**CERTIFICATE OF HIGHWAY MILEAGE
 YEAR ENDING FEBRUARY 10, 2023**

We, the members of the legislative body of **CHITTENDEN** in **RUTLAND** County on an oath state that the mileage of highways, according to Vermont Statutes Annotated, Title 19, Section 305, added 1985, is as follows:

Mileage Certificate Changes 2023
CHITTENDEN TH-4 AND TH-25

Mapping Section
Division of Policy and Planning
Vermont Agency of Transportation -- April 26, 2023

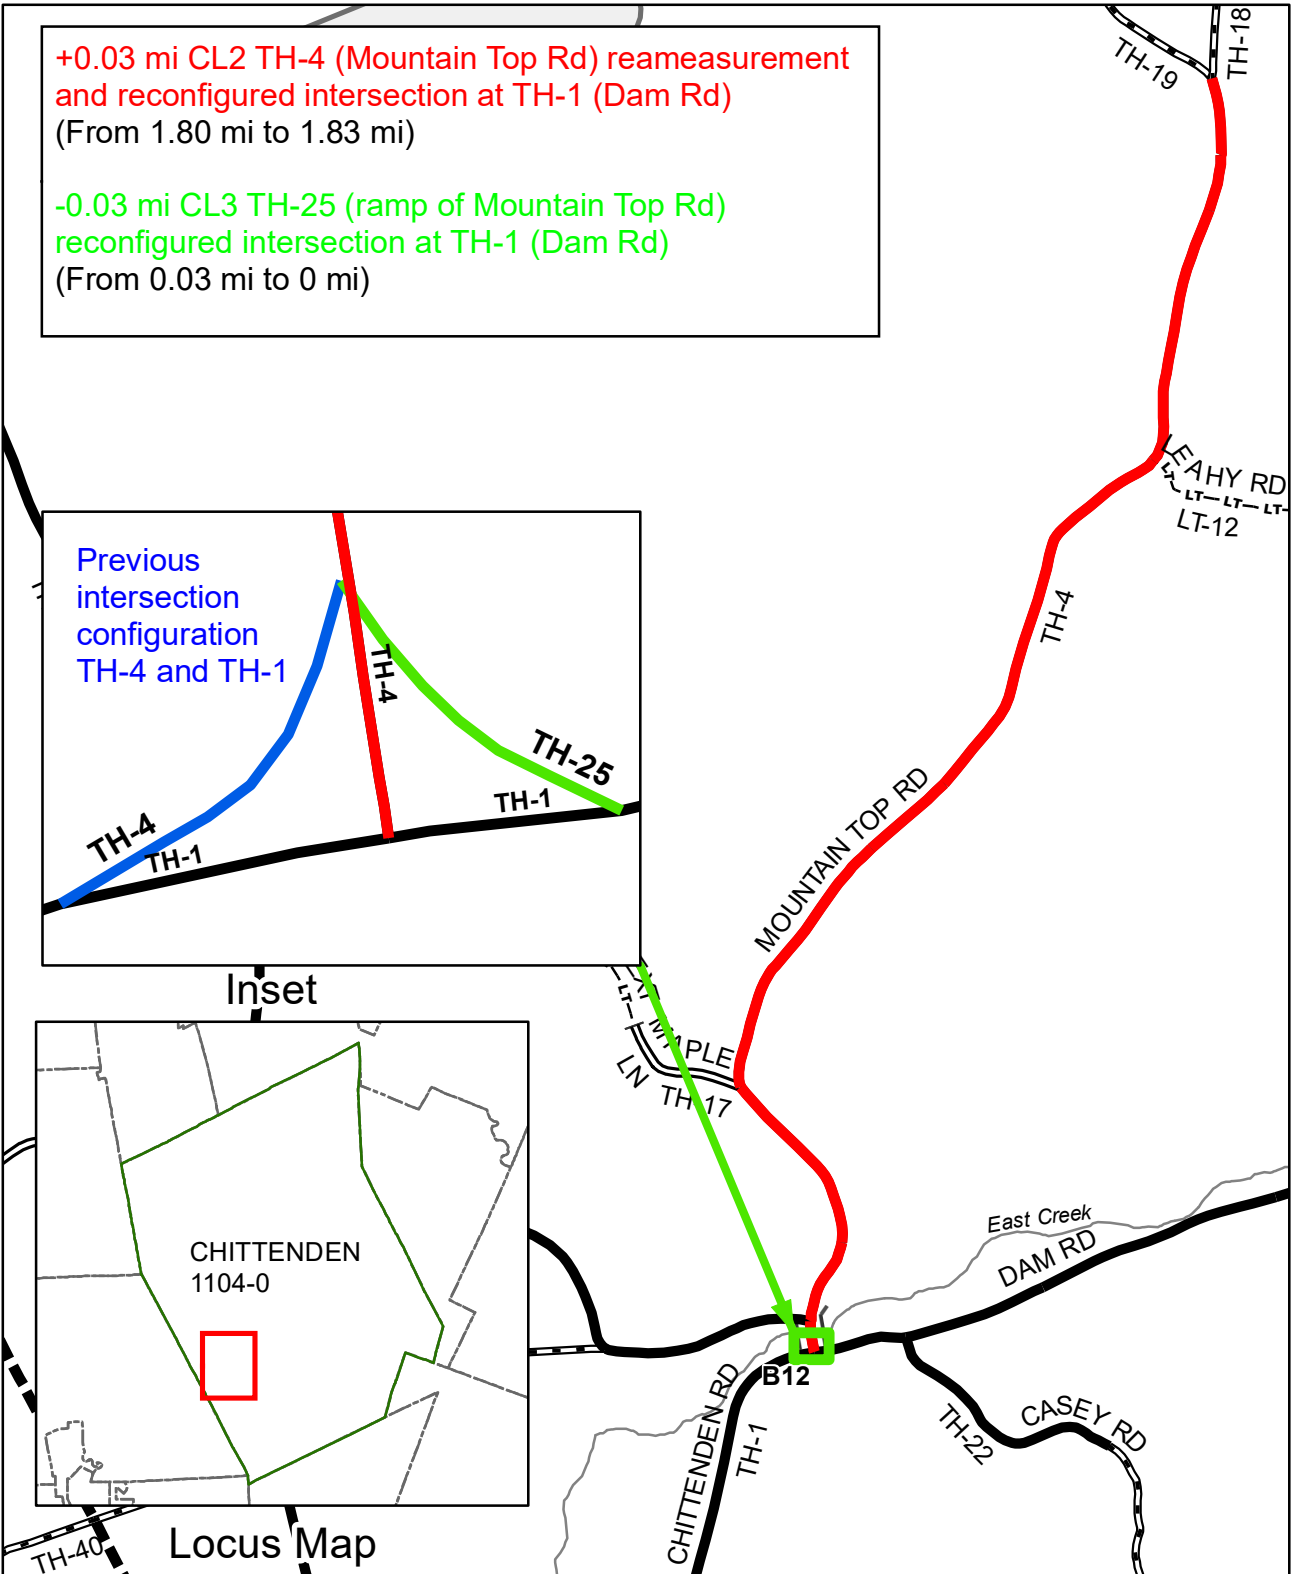
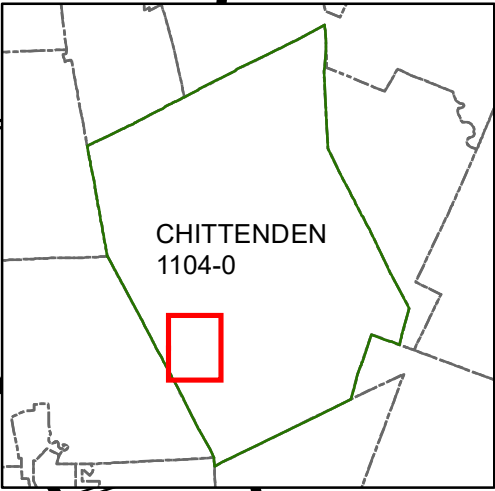
+0.03 mi CL2 TH-4 (Mountain Top Rd) reameasurement and reconfigured intersection at TH-1 (Dam Rd)
(From 1.80 mi to 1.83 mi)

-0.03 mi CL3 TH-25 (ramp of Mountain Top Rd) reconfigured intersection at TH-1 (Dam Rd)
(From 0.03 mi to 0 mi)

**CHITTENDEN
INSET 1**

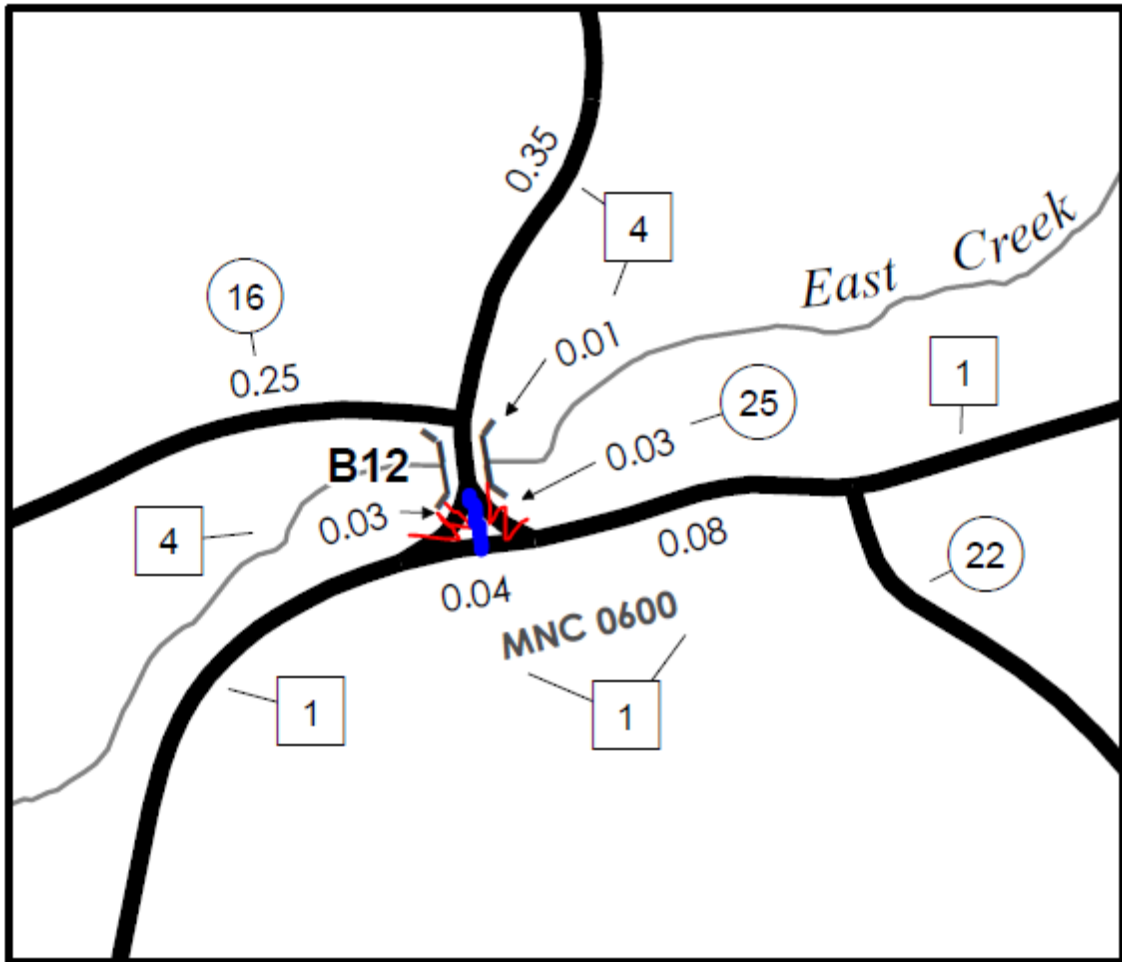
The town of Chittenden reached out to me regarding how to change their annual certificate of mileage to reflect a change in an intersection that was made last year. Per the screen shot below, the town removed the 2 throats of the intersection, marked with red lines. They instead created a "T" intersection, as delineated by the blue line:

Thanks for sending this along and perfect timing, as the mileage certificate process is open right now. Kerry or Pam will reach out to the Town to get any additional info regarding when this project was done and any documentation that we will need for this change. It looks pretty straight forward that the 0.03 miles of TH-23 will go away and TH-4 will be realigned to a "T" intersection. There might be a small adjustment of

mileage for TH-4 and Kerry or Pam will be able to get a sense of this change.

PhotoA

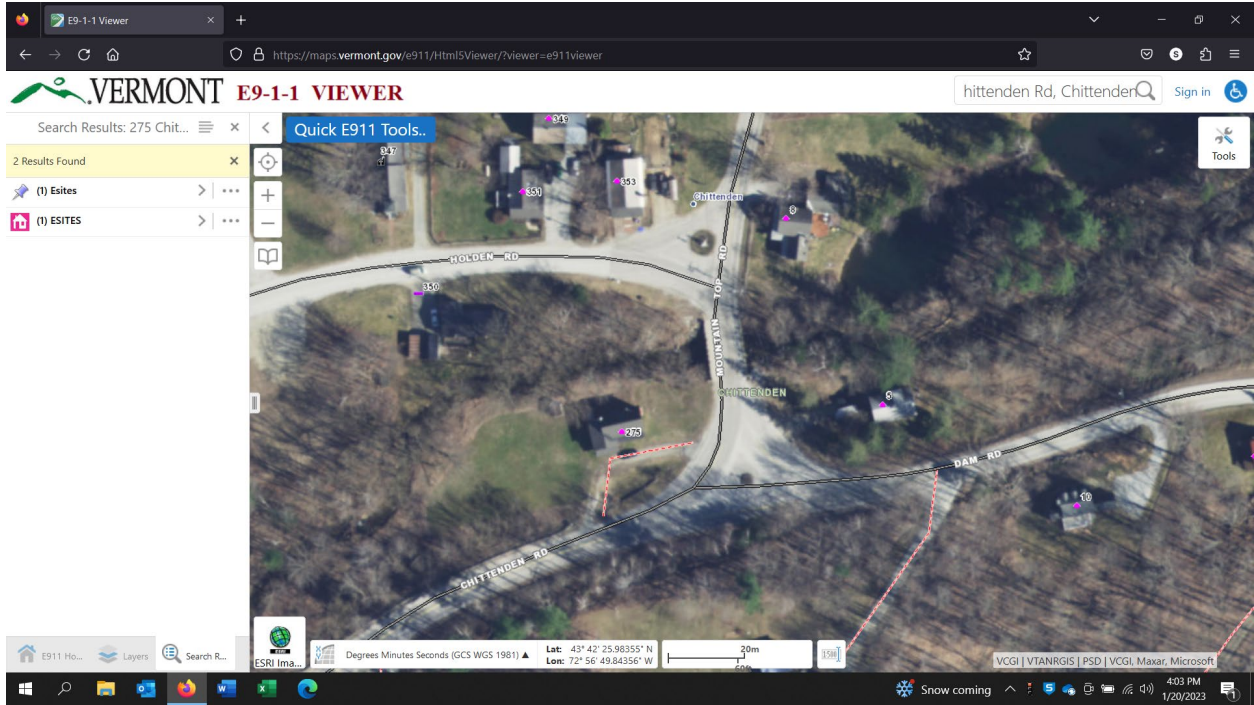
Photo A gives a wider view of the intersection. The upper dot is the Civil War monument. If you look further south and a little to the east of that dot, over the bridge, along Mountain Top Road you will see another dot. That was a planter known as the Circle of Stones. In the reconfiguration of the road, that was eliminated as it became almost the center of the new section of road. In other words, Mountain Top Road continued from the east side of the monument, across the bridge (as before) and straight to the place of the Circle of Stones to join Dam Rd.

Before, the Dam Road/Chittenden Rd intersection started at the southernmost split slip of Mountain Top Road. I would assume that has now moved to the point of the intersection (the former Circle of Stones). Therefore, Chittenden Rd would be a smidgin longer, and Dam Rd would be likewise shorter.

Thank you so much. Yes I see the same imagery in my mapping software or in Google maps as is in E911. Unless you can find something showing it's current alignment, for now, we can draw a line directly through where the planter was and bring it perpendicular to Dam Rd.
